SERVICE NO. 1200 BULLETIN

Date: May 29, 2009 (S)

SUBJECT: LANDING GEAR MODIFICATION AND HARDWARE REPLACEMENT

PA-38-112 Tomahawk

Figure 1
Main Landing Gear
LH shown, RH opposite
Main Landing Gear Fairing Omitted For Clarity

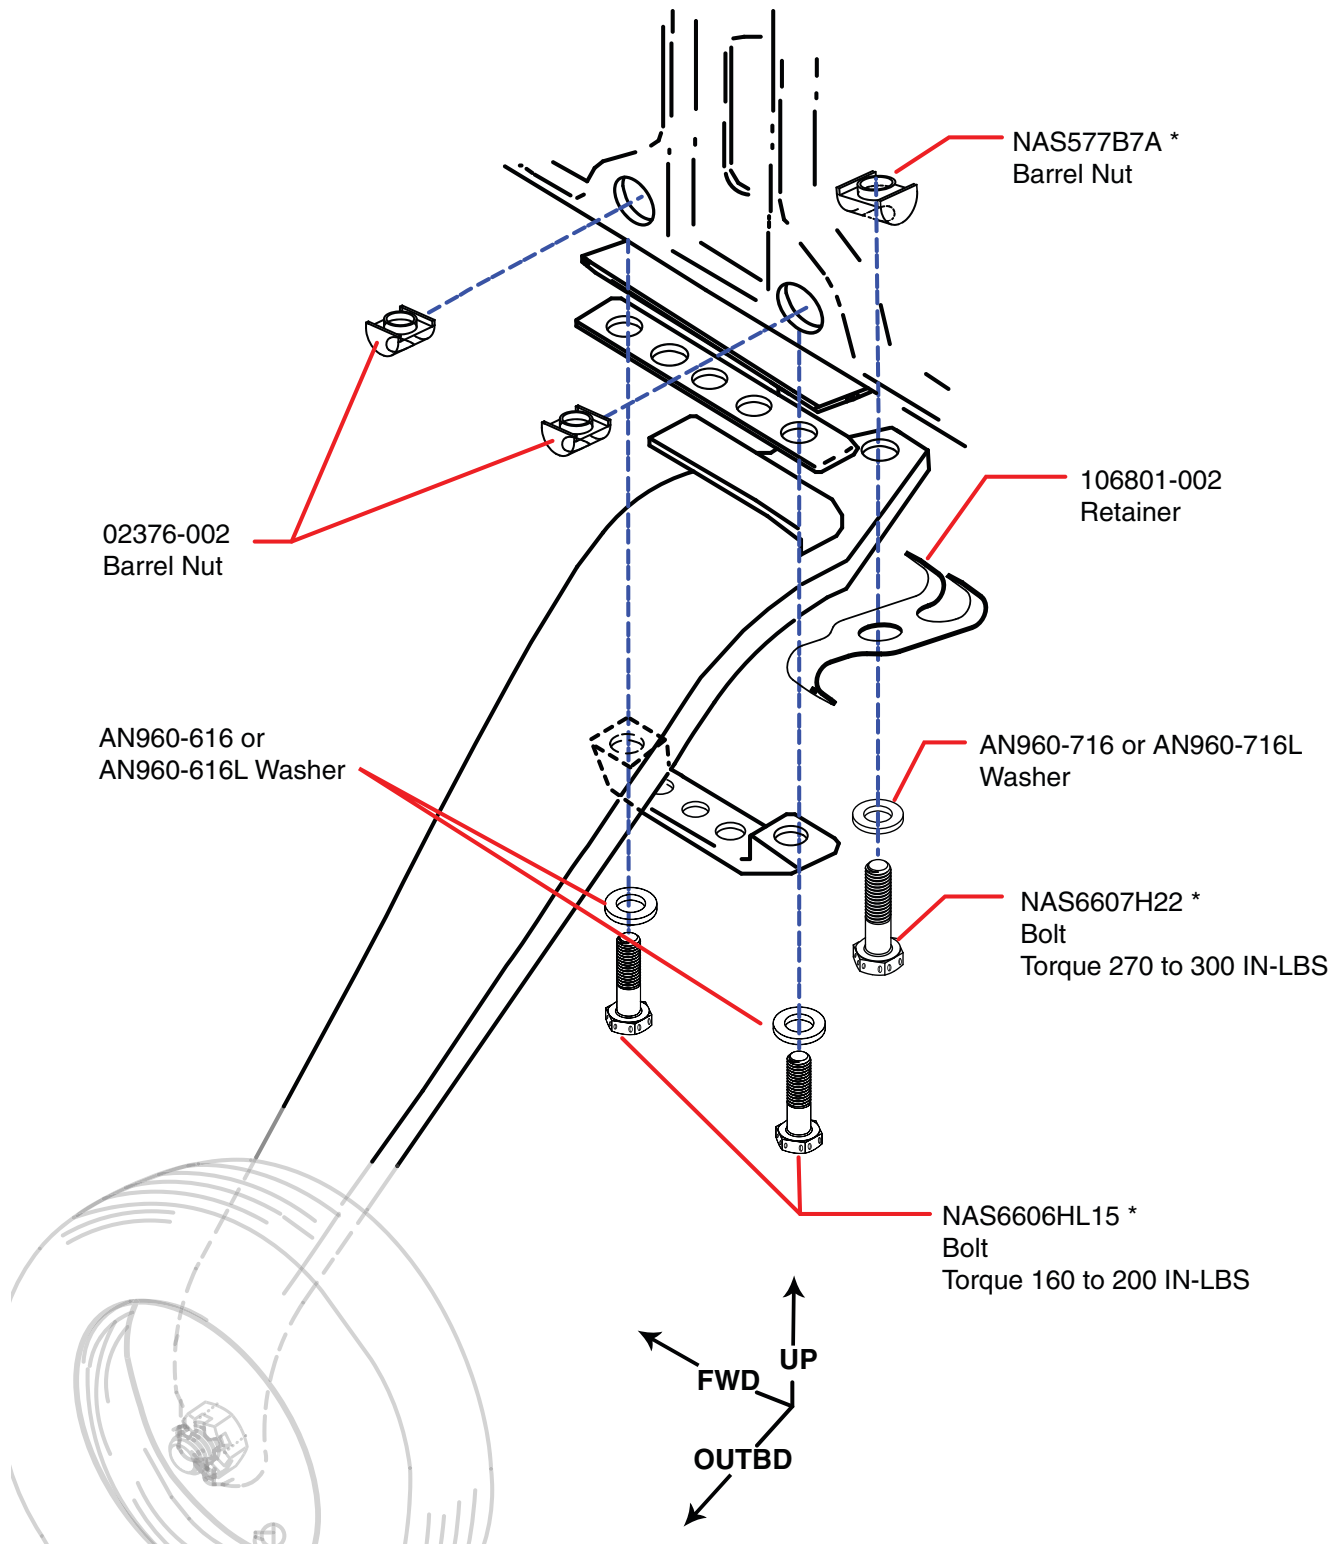
4. Install new replacement hardware, as shown in Figure 1 and as listed in Materials Required - **Table 4**. All other components that are free of damage or corrosion may be re-used at their original locations. Torque bolts according to the following procedure:

- a) Draw up pairs of NAS6606HL15 bolts evenly, 1 or 2 turns maximum per bolt, alternating back and forth until bolts are snug. Install (1 each side) NAS6607H22 bolt, and tighten until snug. Torque should build up gradually for all bolts. An abrupt buildup indicates threads are bottoming in the barrel nut.

- b) With all bolts installed and snug, torque the (2 each side) NAS6606HL15 bolts 160 to 200 inch-pounds, and torque the (1 each side) NAS6607H22 bolts 270 to 300 inch-pounds. Examine bolt thread penetration during and after torquing.

- For the (2 each side) NAS6606HL15 bolts, the end of bolt must be at least flush with barrel nut after torquing. If bolt extends into clearance hole, or threads bottom out as described above, add additional AN960-616 or AN960-616L washer under bolt head to achieve proper bolt grip. The saddle clamp and shim should fit snugly against the wing. See **Table 1** for interchangeability with NAS1149 washers.

- For the (1 each side) NAS6607H22 bolts, at least one complete bolt thread must protrude visibly through the barrel nut after torquing. If bolt extends into clearance hole, or threads bottom out as described above, add additional AN960-716 or AN960-716L washer under bolt head to achieve proper bolt grip. See **Table 1** for interchangeability with NAS1149 washers.
